ATB 52056 (1407)

Safety Recall: Wrong A-Pillar Trim Is Installed

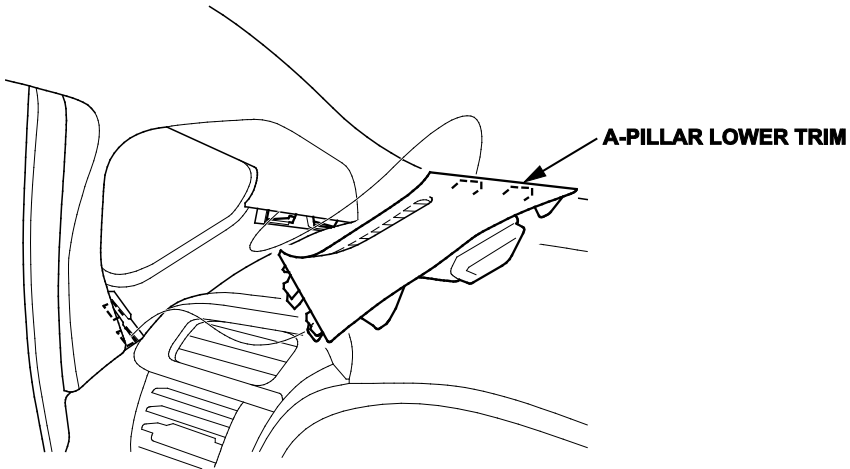
1. Look for a "SIDE CURTAIN AIRBAG" stamp on the left and right A-pillar trim.
 - If the A-pillar trim has "SIDE CURTAIN AIRBAG" stamped on it, the vehicle is OK. No further action is needed.
 - If the A-pillar trim does not have "SIDE CURTAIN AIRBAG" stamped on it, go to REPAIR PROCEDURE.
